DCT.GDANSK.SA
Deepwater Container Terminal Gdansk

04/EU/2018/RS

REGARDING PURCHASE AND DELIVERY OF 2 REACHSACKERS

Q&A table regarding technical specification (Employer's requirements) in accordance with point 5.6 of Terms of Tender.

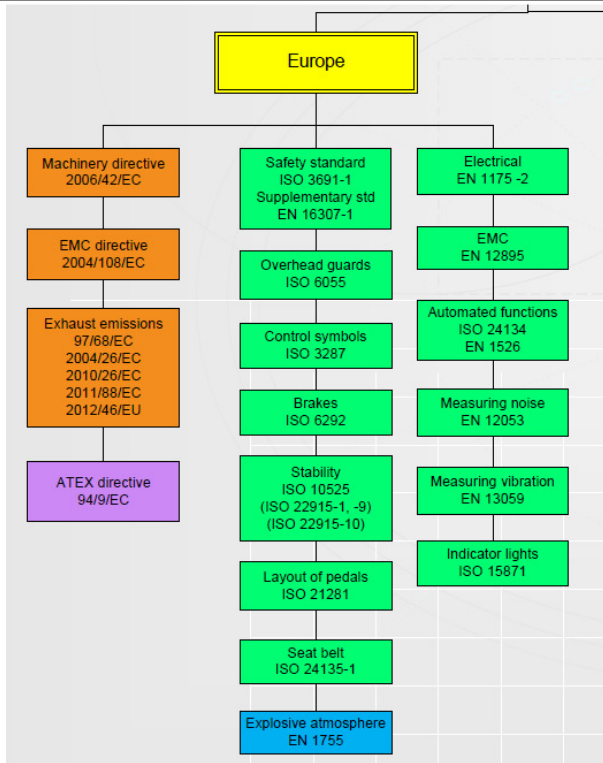
12	<p>6.6 Chassis – wording after ‘Counterweight of Reachstacker shall be painted as described below.’ Do we understand right that rear counterweight looking for the rear of machine plus both upper sided right/left have to be painted in stripes black/yellow as described further in points 6.2.2 (painting drawing) and 6.3.5 and text in point 6.6 is only an addition meaning the same? Thank you.</p>	<p>Yes, point 6.6 there should be “as mentioned above” instead of “as mentioned below”.</p>
13	<p>7.1 – ignition key. Please be informed that key type no. 014603 is nowadays outdated and not used anymore by many machine suppliers. It is superseded by modern type key (shown below). It is used for ignition and also for cabin door locking (same key). Please accept.</p> 	<p>We do accept. Please quote 200 pcs. in spare parts list.</p>
14	<p>7.1 – main battery switch. Please advise what LOTO means.</p>	<p>It stands for: “Lockout- Tagout” system</p>

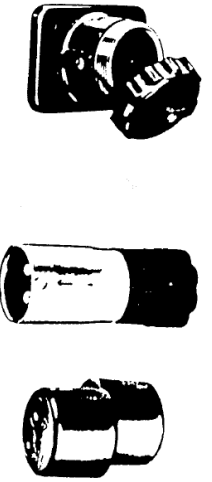
7.1 NATO socket – please kindly accept 24V permanent 160 A (10 s 400 A) NATO socket for jump starting. This type is more than enough for easy and proper reachstacker battery fast charging. Specification from our supplier below. Thank you.

Yes, we do accept.
